**Re: Permit No. M-1980-244; Cripple Creek & Victor Gold Mining Company; Cresson Project; – Technical Revision 125 PAR Response – VLF 2 Phase 2B, Part 2 Record of Construction – Construction Quality Assurance Report**

**ATTACHMENT 1:**  
**Appendix J.5.1**

**ATTACHMENT 2:**  
**UPDATED GEOMENBRANE PANEL LAYOUT AS-BUILT (DRAWING 6)**

**SQUAW GULCH VALLEY LEACH FACILITY  
PHASE 2B PART 2  
RECORD OF CONSTRUCTION REPORT Rev 1**

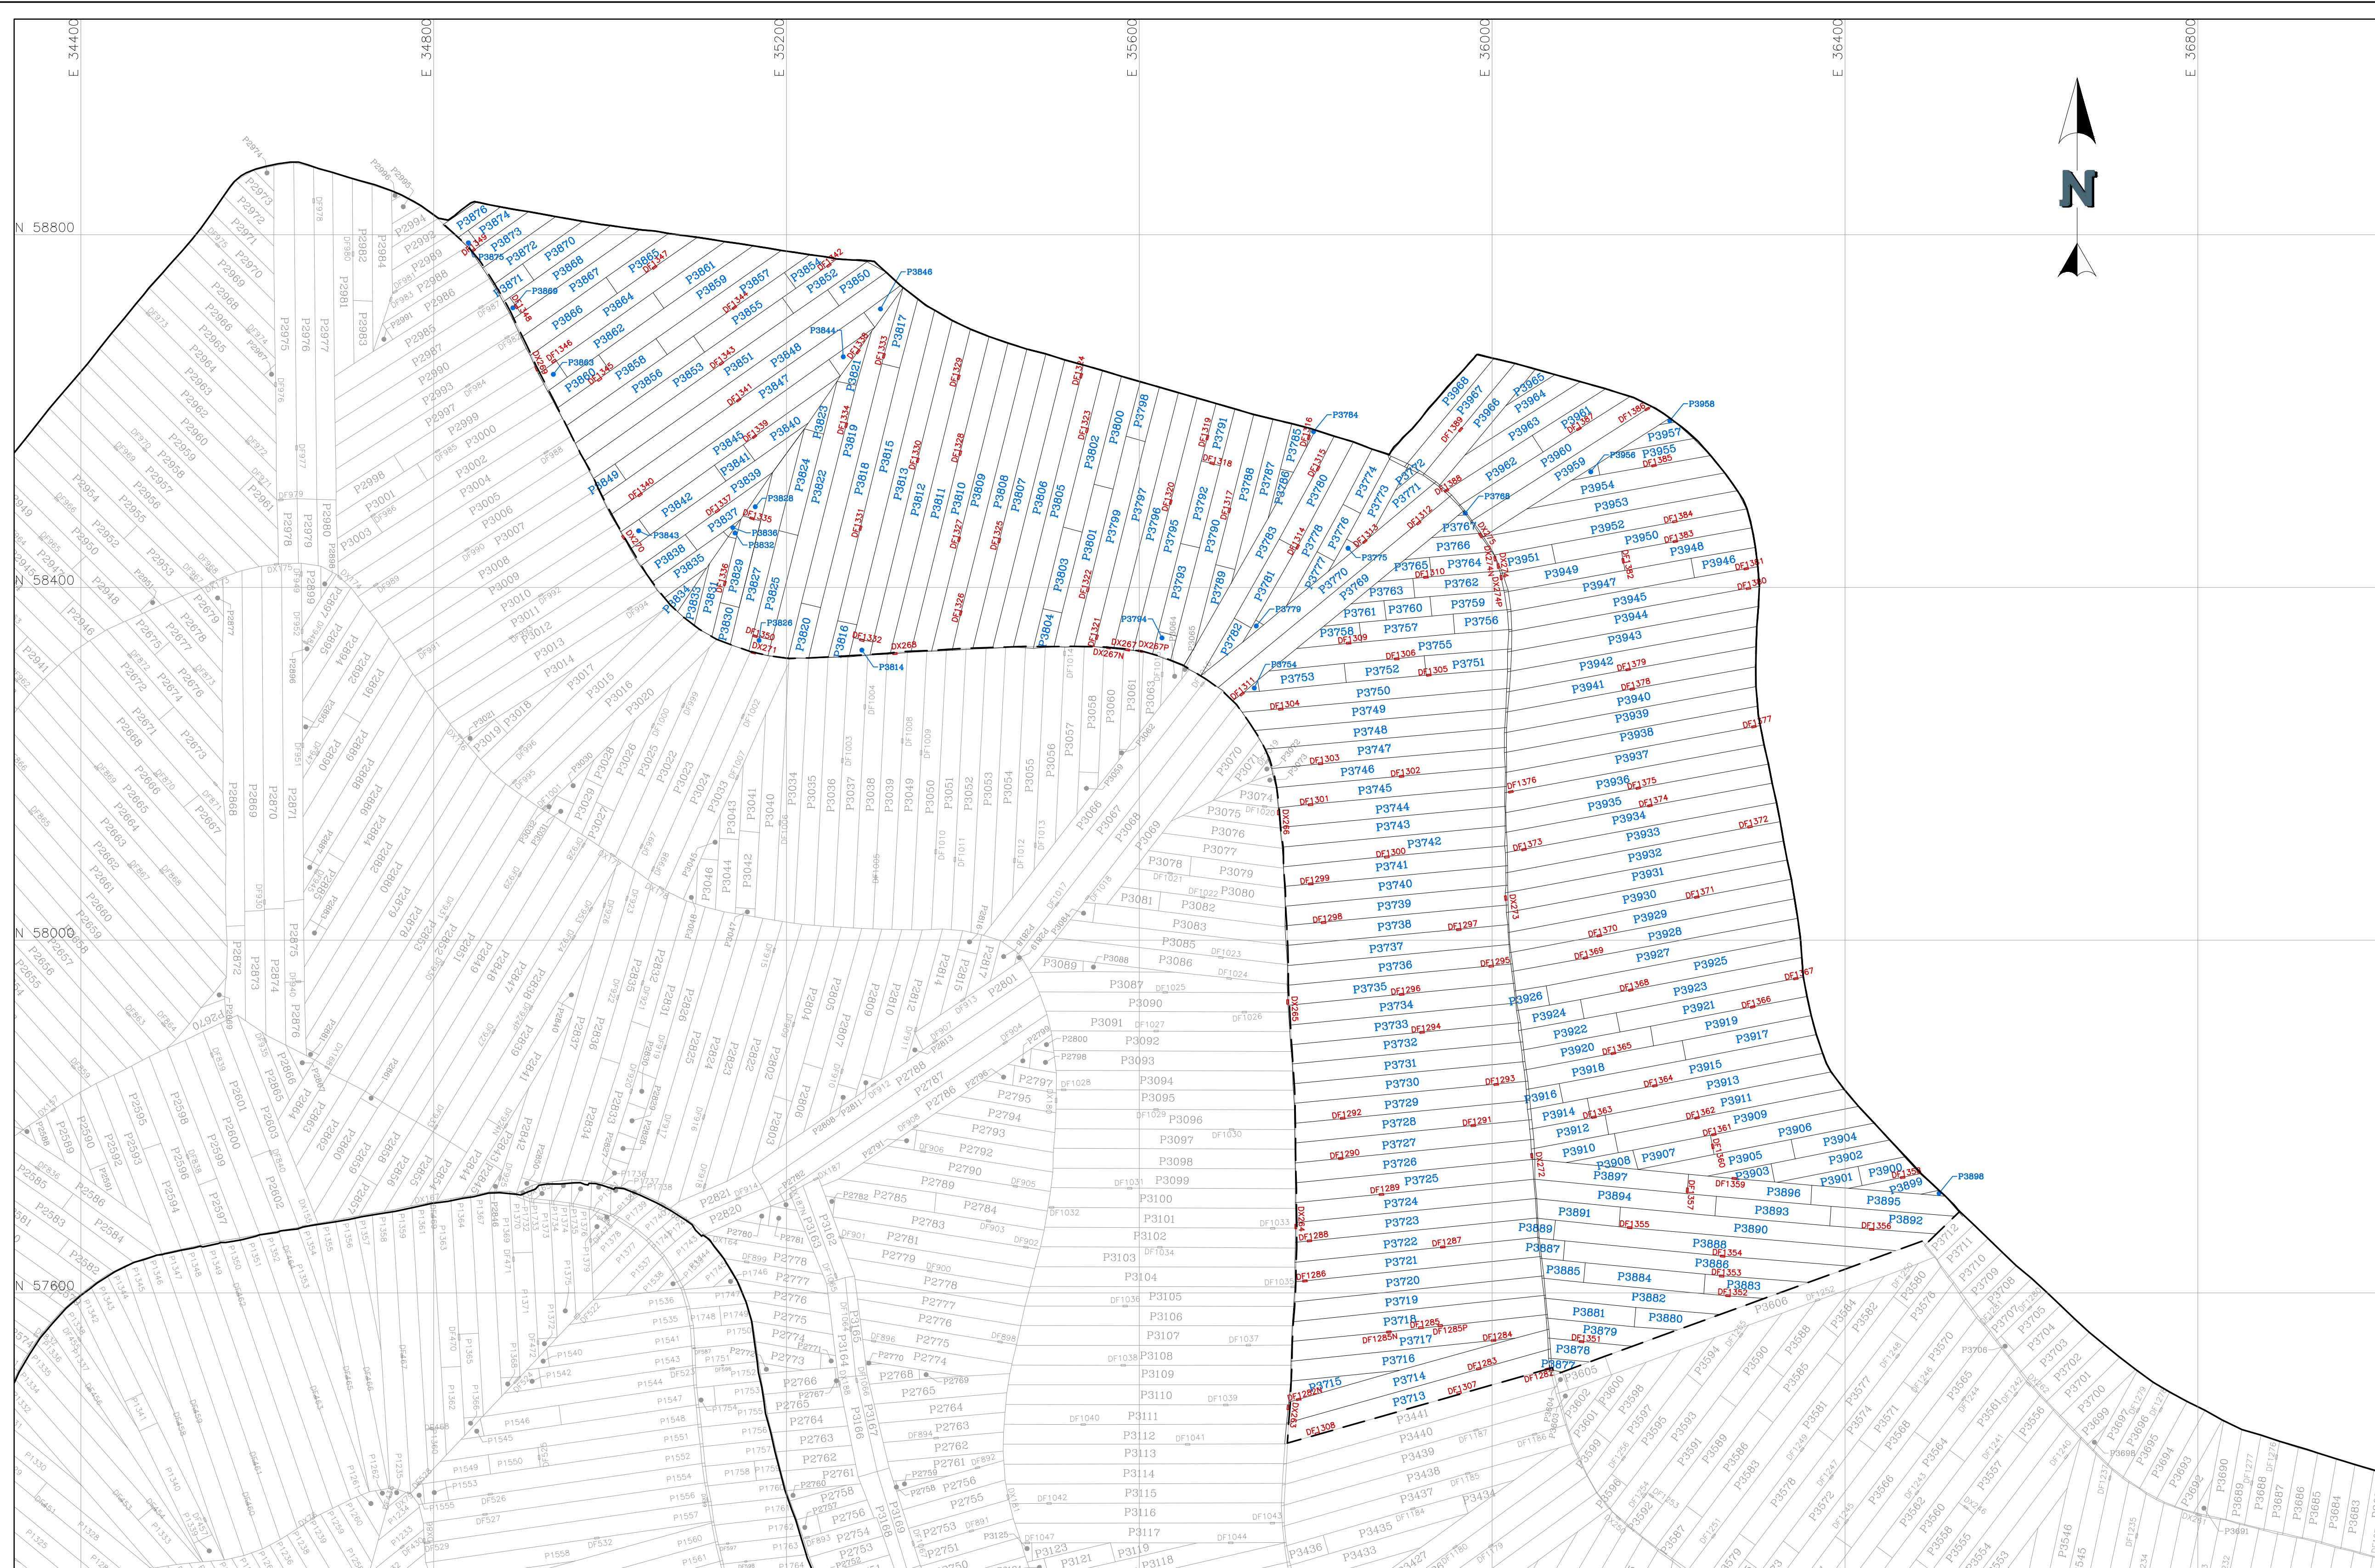
- c. In Appendix J 5.1 DF-1321 is located on P-3797/P-3801 but on Drawing No. 6 it is located on P-3797/P-3799, please resolve and update accordingly.

- d. In Appendix J 5.1 DF-1339 is located on P-3840/P-3844 but on Drawing No. 6 it is located on P-3840/P-3845, please resolve and update accordingly.

- e. In Appendix J 5.1 DF-1345 is located on P-3850/P-3860 but on Drawing No. 6 it is located on P-3858/P-3860, please resolve and update accordingly.

- f. In Appendix J 5.1 DF-1350 located on P-3825/P-3826 is missing from Drawing No. 6, update.
  - g. In Appendix J 5.1 DF-1387 is located on P-3960/P-3962 but on Drawing No. 6 it is located on P-3960/P-3961, please resolve and update accordingly.

- h. In Appendix J 5.1 DF-1388 is located on P-3963/P-3964 but on Drawing No. 6 it is located on P-3962/P-3963, please resolve and update accordingly.

- c) **The location of DF-1321 is P-3797/P-3799 and has been updated in Appendix J.5.1. Updated Appendix J.5.1 is attached.**
  - d) **The location of DF-1339 is P-3840/P-3845 and has been updated in Appendix J.5.1.**

- e) **The location of DF-1345 is P-3858/P-3860 and has been updated in Appendix J.5.1.**
  - f) **Enclosed, DF-1350 has been added to the correct location on Drawing No. 6.**

- g) **The location of DF-1387 is P-3960/P-3961 and has been updated in Appendix J.5.1.**
  - h) **The location of DF-1388 is P-3962/P-3963 and has been updated in Appendix J.5.1.**
